# Georgia Institute of Technology

NEELY NUCLEAR RESEARCH CENTER  
900 ATLANTIC DRIVE  
ATLANTA, GEORGIA 30332-0425

Re: Docket No. 50-160, License No. R-97

On behalf of the Georgia Institute of Technology, I hereby request that the Nuclear Regulatory Commission amend Facility Operating License No. R-97 so that Fast Shutdown System (FSS) experiments (described in Appendix A) may be conducted at the Georgia Tech Research Reactor. The following are the applicable portions of the Technical Specifications (TS) that will require amendment.

Figure 1. One Second Delay Unit

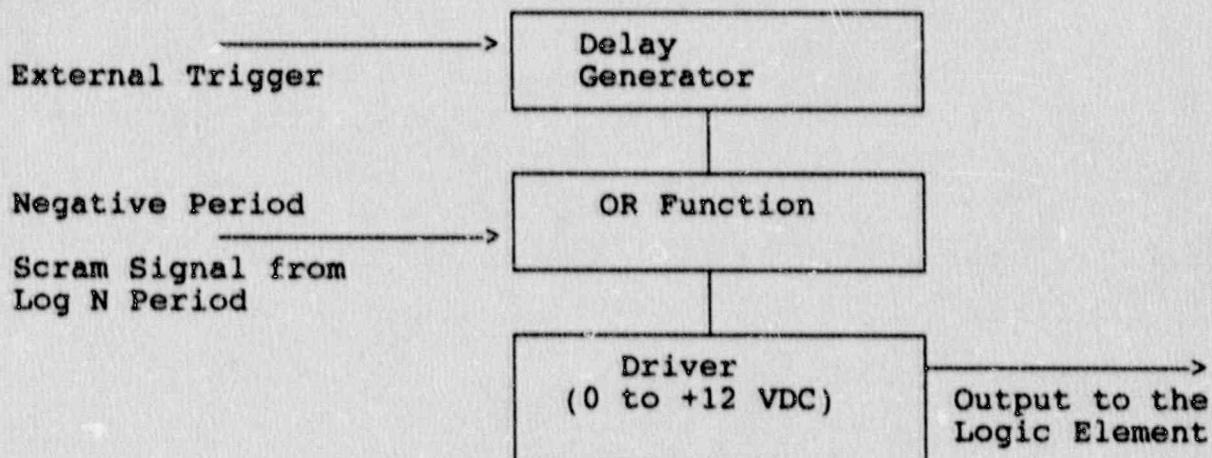
**REQUESTED CHANGE** - It is requested that permission be given to delay the actuation signal for the negative period trip by one second so that the flux as a function of time can be monitored and studied. The one second delay is requested to be in effect during the FSS experiments only.

The one second delay logic is shown in Figure 1. Figure 2 shows how the one second delay unit is incorporated into the GTRR circuit.

The Negative Period Scram signal is normally at +12 VDC and near ground level for scram condition. The level of the Scram signal will be sent to Logic Element except for the time the Delay Generator output is high; during that time the output to the Logic Element will be +12 VDC regardless of the level of the Scram signal.
